Interactive comment on “Eutrophication mitigation in rivers: 30 years of trends and seasonality changes in biogeochemistry of the Loire River (1980–2012)” by C. Minaudo et al.

C. Minaudo et al.

Received and published: 3 February 2015

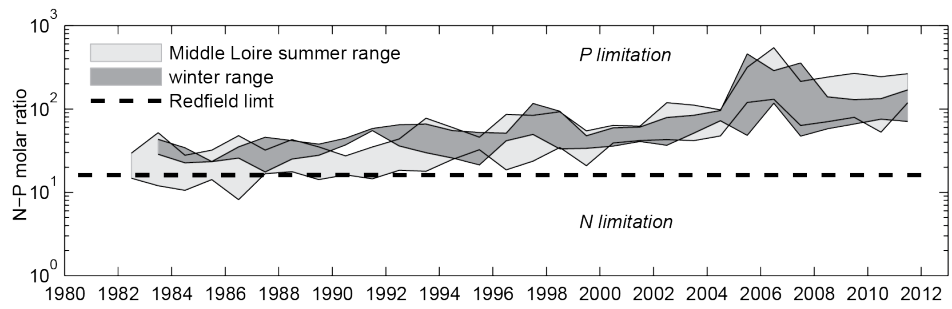
RC: The N:P molar ratio was calculated on N and P concentration in the water: it never can be used to infer N or P limitation: that leads to the wrong conclusion that the R. Loire "has always been P-limited"; P-limitation can be assessed from measurement of sestonic (i.e. particulate) or total, not dissolved, nutrient concentrations that in most systems helps assessing phytoplankton nutrient status, on which the reasoning based on the Redfield ratio applies; the conclusion is contradicted by the data on SRP concentration: phytoplankton limitation can't occur when at SRP concentrations at $\sim 200 \mu\text{g/L}$; the authors should consider that light limitation of phytoplankton is more likely when SRP levels were high and that, given the high dissolved N concentration, N could never be limiting or even co-limiting; P limitation of phytoplankton growth has indeed appeared as a result of P reduction measures in the Loire basin (see for instance Oudin et al, 2009 and Descy et al 2011).

AC: Although we found several references using DIN:DIP ratios for determining which among N and P is the limiting nutrient in different large rivers (Elbe, Rhone, Danube, Mississippi), we understand that it is not appropriate. As highlighted in the literature on the subject (Reynolds 1992, "What Vollenweider couldn't tell us"), the usefulness of citing nutrient ratios probably lies in determining which, if at all, is likely to become limiting during the phytoplankton increase phase.

We unfortunately don't have any data from measurements of sestonic N and P during the period 1980-2012, but to make sure we present in our paper the right evolution of the N:P ratio, we re-calculated this ratio with $N_{\text{tot}} = \text{NO}_3 + \text{NO}_2 + \text{NKj}$ and P_{tot} . Thus, we add a couple lines in the Methods section to explain how the N:P ratio was calculated. The results constitute the new version of Figure 5, which can be seen at the bottom of this document.

These results indicate that P-limitation of phytoplankton growth has become a very significant factor. When the river hydrology remains stable in the summer, phytoplankton is potentially under P-limitation, suggesting an explanation for the apparent shift in seasonal phases of Chl. a concentrations (late summer blooms no longer occur, described in section 3.2).
